Staff Report

Cloverleaf Truro Rental Housing Comprehensive Permit

SITE PLAN
CLOVER LEAF DRIVE, OFF HIGHLAND ROAD, TRURO, MA

Re: Peer Review
Cloverleaf Parcel
Highland Road
Truro, Massachusetts

Figure 1

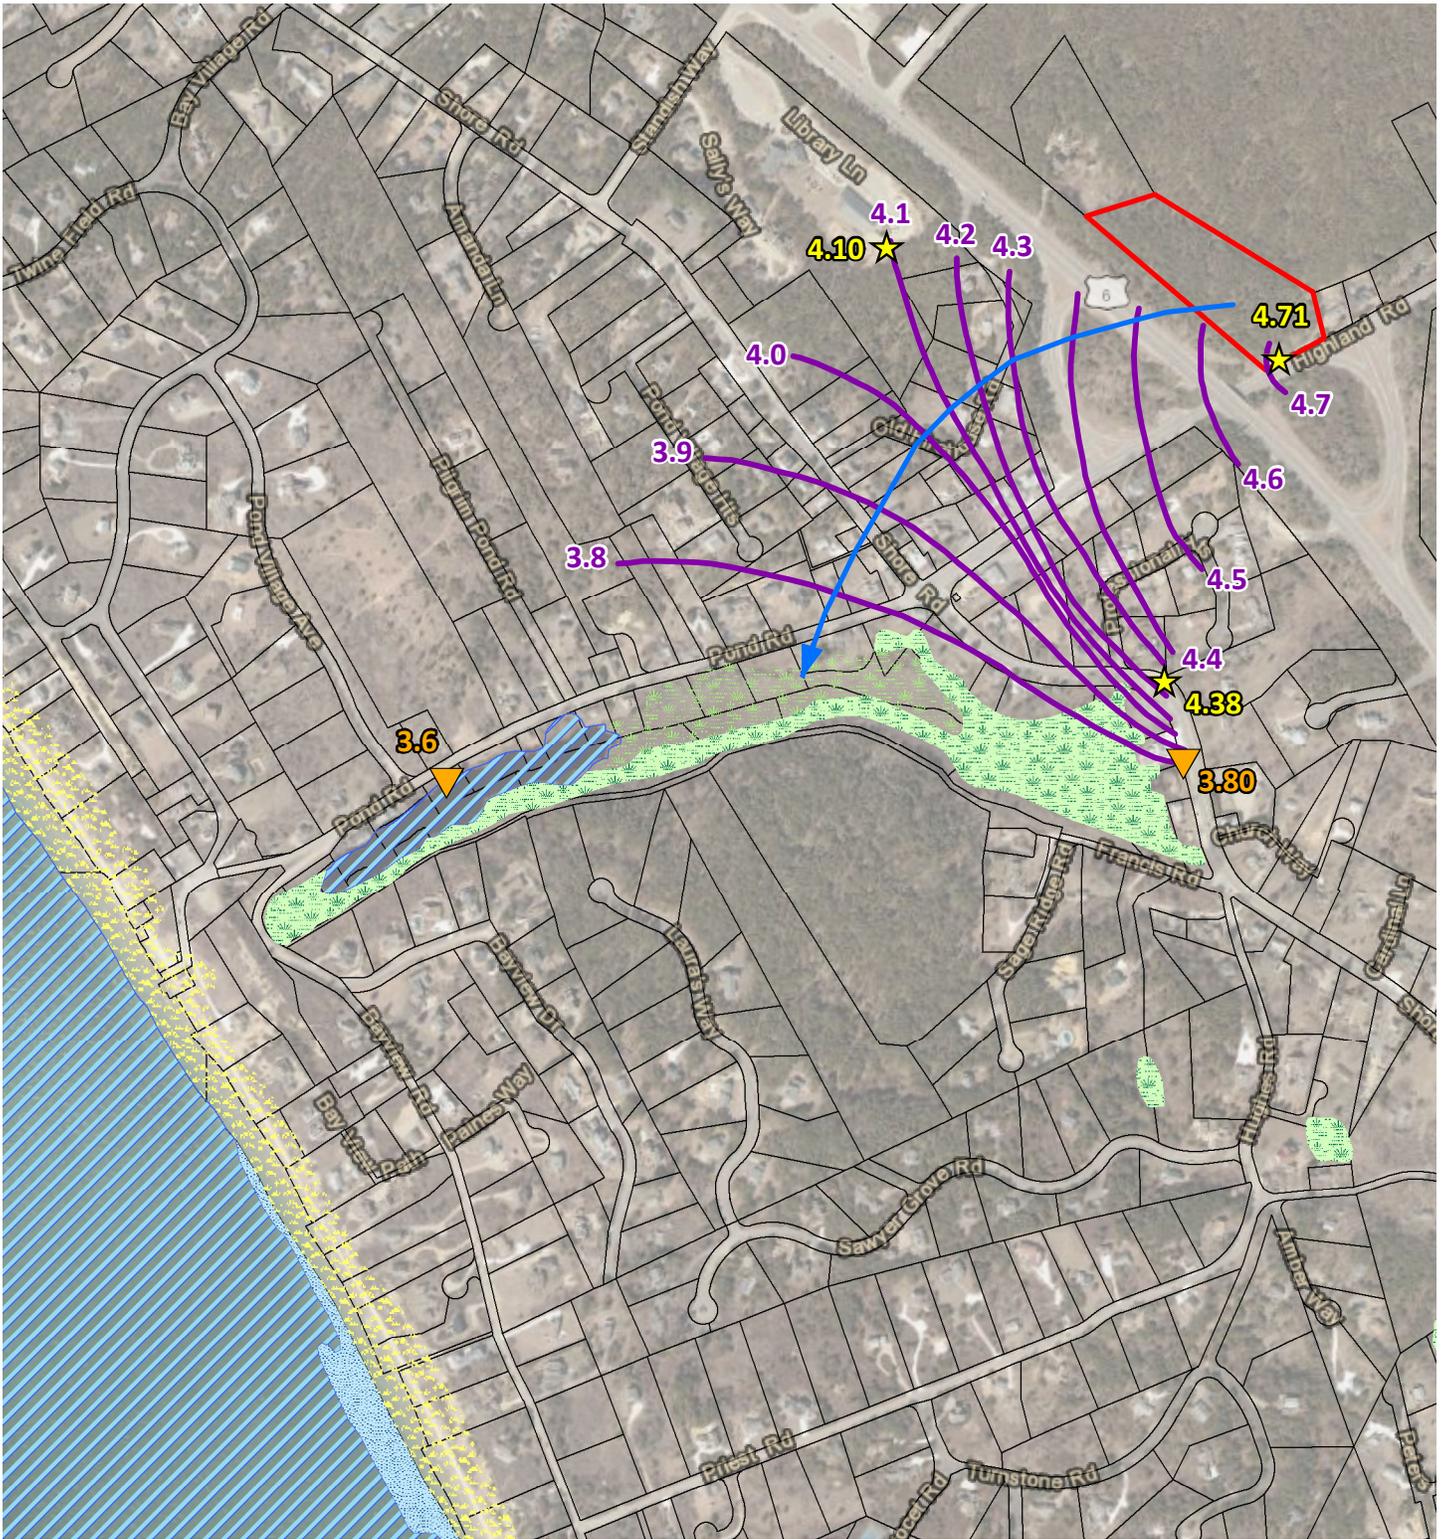
On January 27 and 28, 2020, HW installed 3 groundwater monitoring wells (B1, B2 and B3) off-site and downgradient of the proposed housing development. On February 4, 2020, depth to water measurements were collected at the three groundwater monitoring wells as well as the culvert outfall off of Shore Road and Village Pond. These sample locations and groundwater contours can be found as Figure 1. Groundwater in the vicinity of the site flows to generally to the south, across Route 6 and eventually flows into Pilgrim Pond or the surrounding wetland resources.
